# Metro 31

City of El Paso — City Plan Commission — 4/4/2019

**SUSC18-00012 — Resubdivision Combination REVISED**

# ATTACHMENT 2

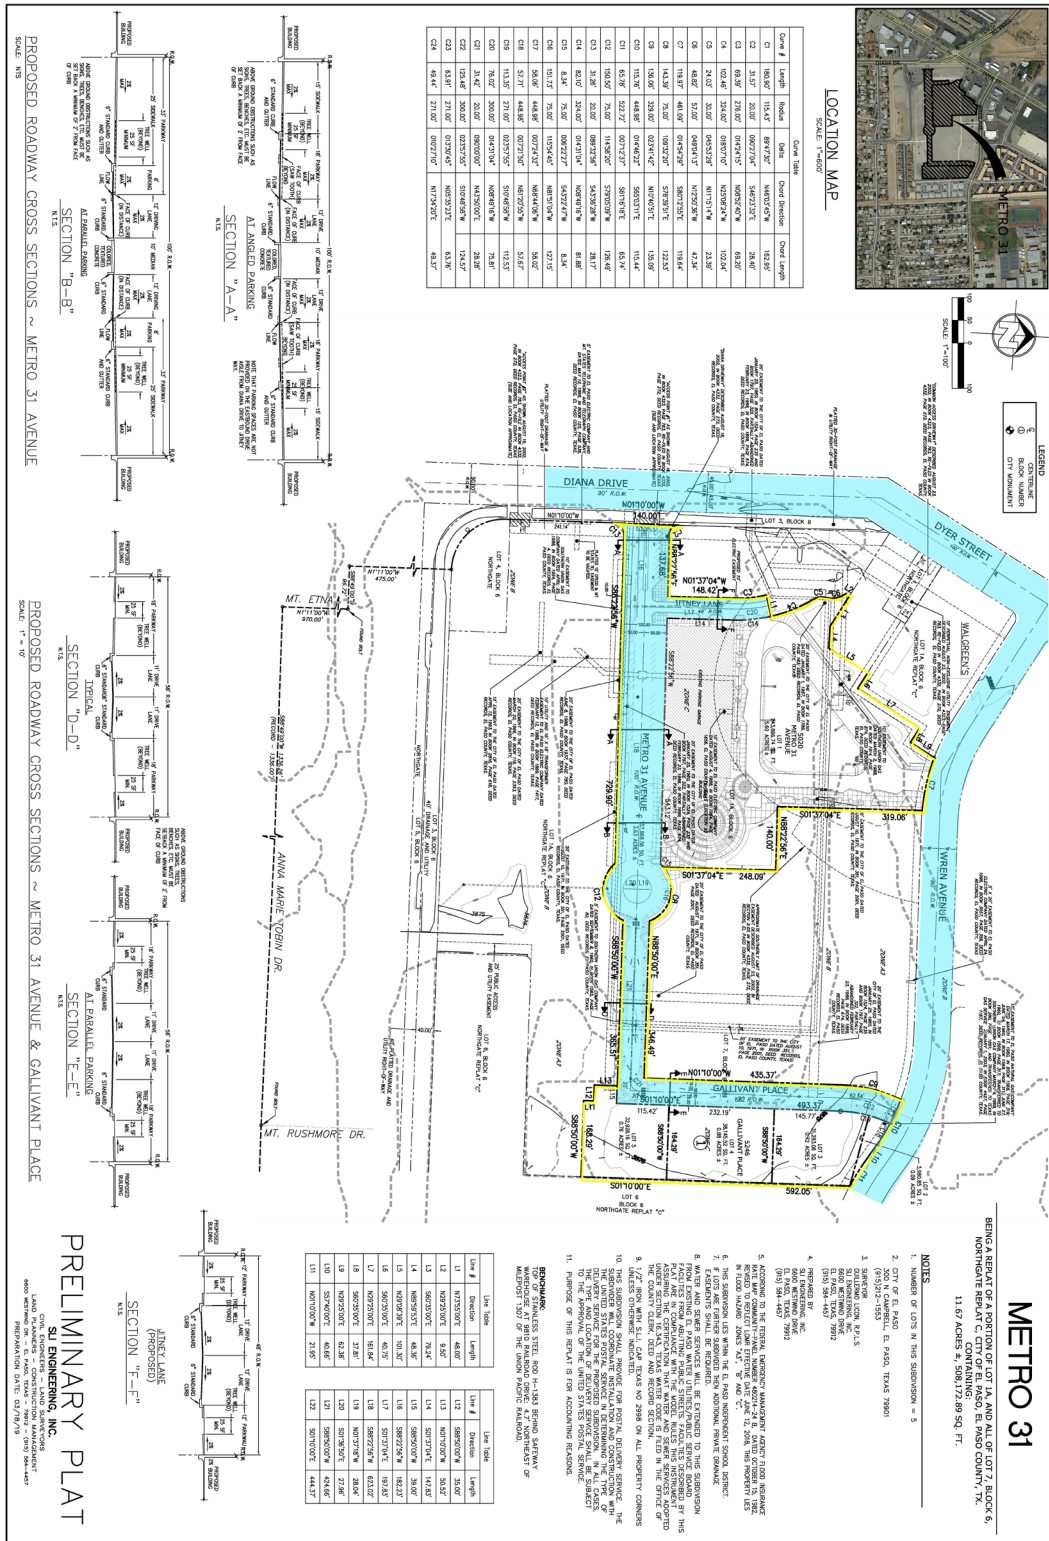
1. Please verify addresses. For lots on the north side of Metro 31 Avenue should be odd numbers.
2. Label the owner in note two on the preliminary plat.

3. Clarify the purpose of the replat.
4. Label cross-sections to match the Regulating Plan.
5. Submit to the Planning & Inspections Department – Planning Division the following prior to recording of the subdivision:

1. On March 29, 2019, the Consolidated Review Committee approved a Preliminary Building Scale Plan (PLBS19-00002) and Regulating Plan Adjustment (PLRP19-00002) for the proposed development.
2. Please add the thoroughfare assembly nomenclature used in the Metro 31 SmartCode Regulating Plan (eg., "GALLIVANT PLACE (ST 58-38)") to the preliminary plat.

1. Show existing retention private pond on the Preliminary Plat and clarify if it is permanent or temporary.

1. Please provide correct cross-sections for Metro 31 Avenue and Gallivant Place.
2. Please ensure that proposed cross-sections are labeled to match the approved Metro 31 Regulating Plan.

Comments have been addressed
